TECHNICAL BULLETIN

File No.:	TB-9606A (1 of 3)	Date:	May 31, 1996
Model:	FT-1000MP	Serial No. Range:	All problem units.

Problem:	Antenna won't tune on 15 meter band.
-----------------	--------------------------------------

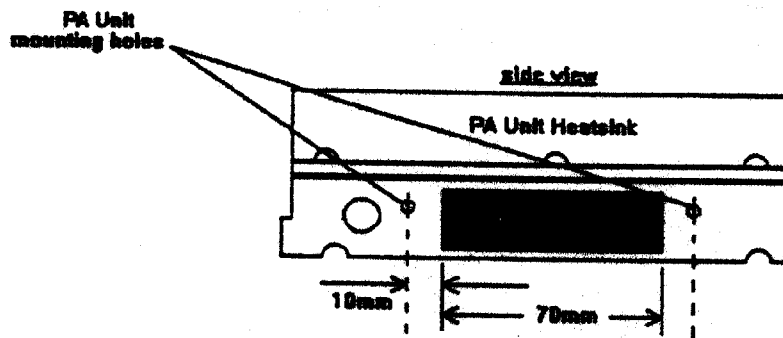
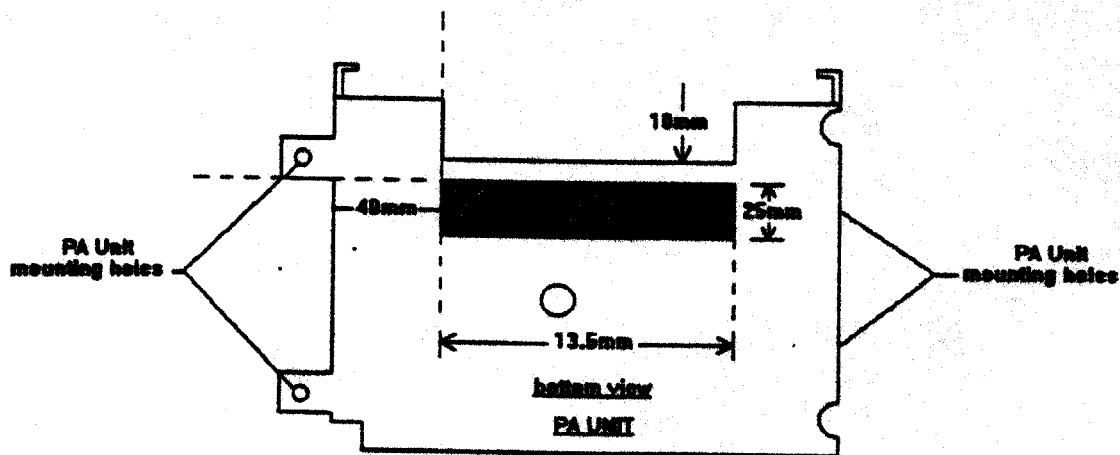
6. Solder a piece of copper braid between the BPF UNIT and the small enclosure as shown in the pictorial.
7. Following the pictorial, You will add stick on copper tape to the bottom of the PA UNIT where the spring contacts (2 of them) on the RF UNIT come in contact with the bottom of the PA UNIT. (Spring contact on small enclosure does not need copper tape).

8. Following the pictorial, add a stick on piece of copper tape to the left side of the PA UNIT to improve the bond to chassis ground.
9. Following the pictorial, use cable ties to tie the 2 cables by the small shielded enclosure and dress them to the side of the enclosure.

NEW COIL MOUNTING DETAIL

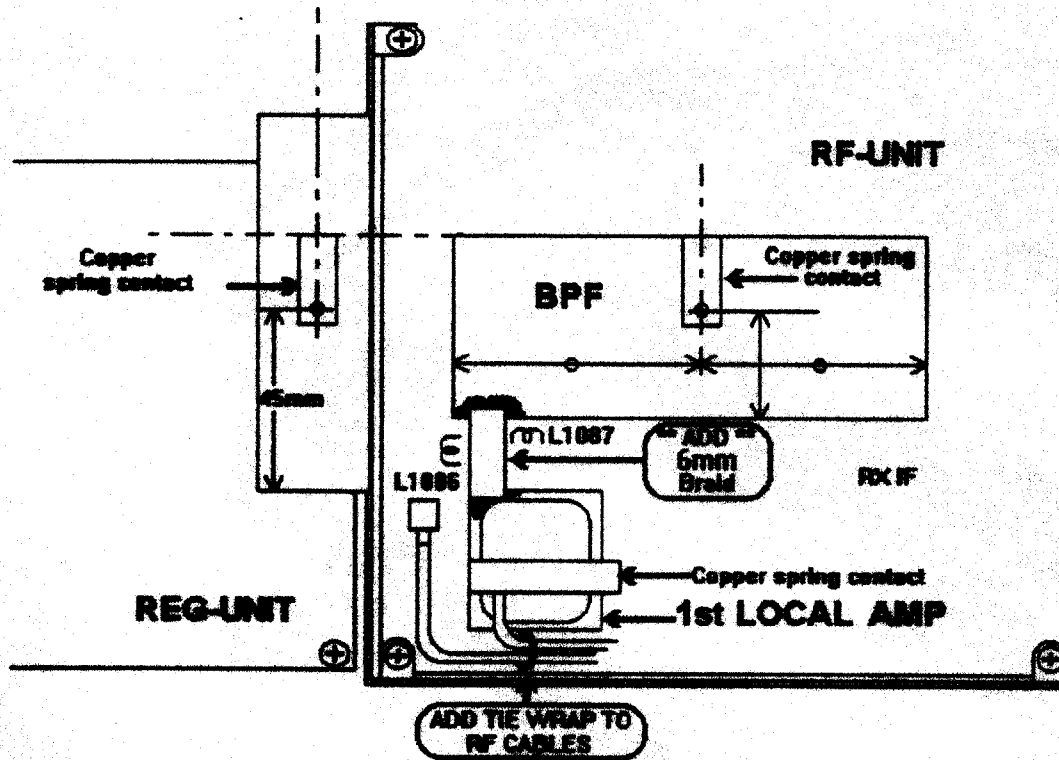
L1086 - L1087

BEND LEADS STRAIGHT DOWN
AND AT RIGHT ANGLES

10. Remove L1086 & L1087 and replace with part numbers listed above.
11. Reassemble radio and test for correct operation.
